PCN – Product Change Notification

PCN-A-1101019

PCN Topic: Update 8.4 inches Panel Mount Drawing_R08T200-PMT1, R08L100-OFU3

The below pictures show the example of how the new drawing differ from the original one.

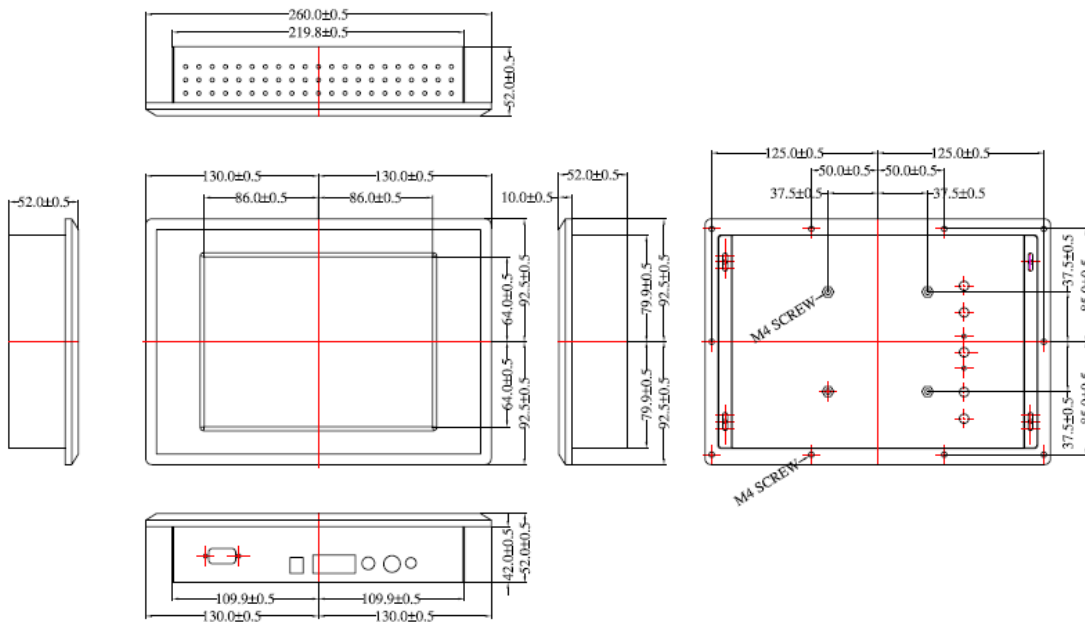
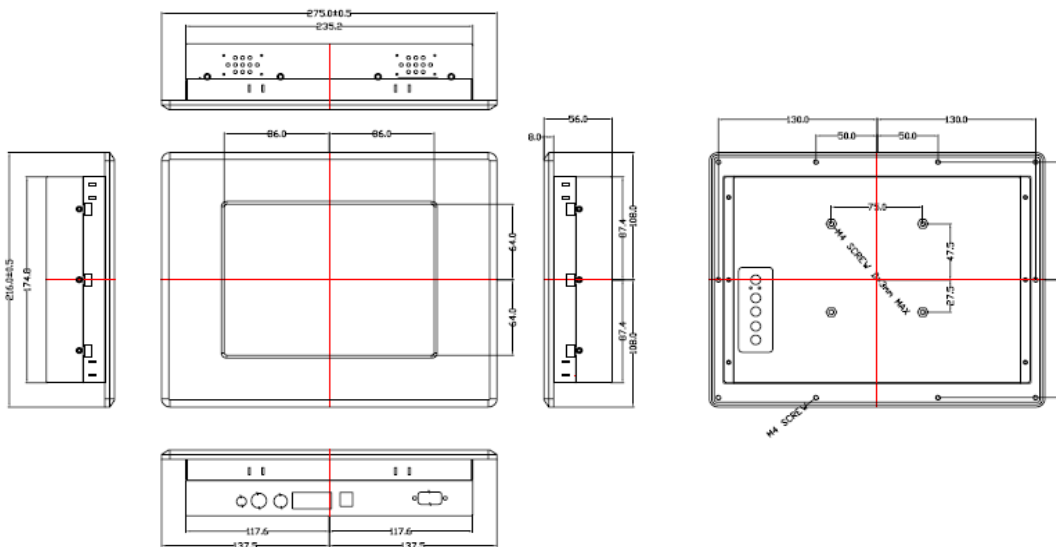
We have released new 8.4 inches Panel Mount LCD drawing for the model of R08T200-PMT1 & R08L100-OFU3. The main change is the change of the thickness of Aluminum front bezel.

The dimension of this model will be change from 260*185*52 (W*L*D) to 275*216*56.
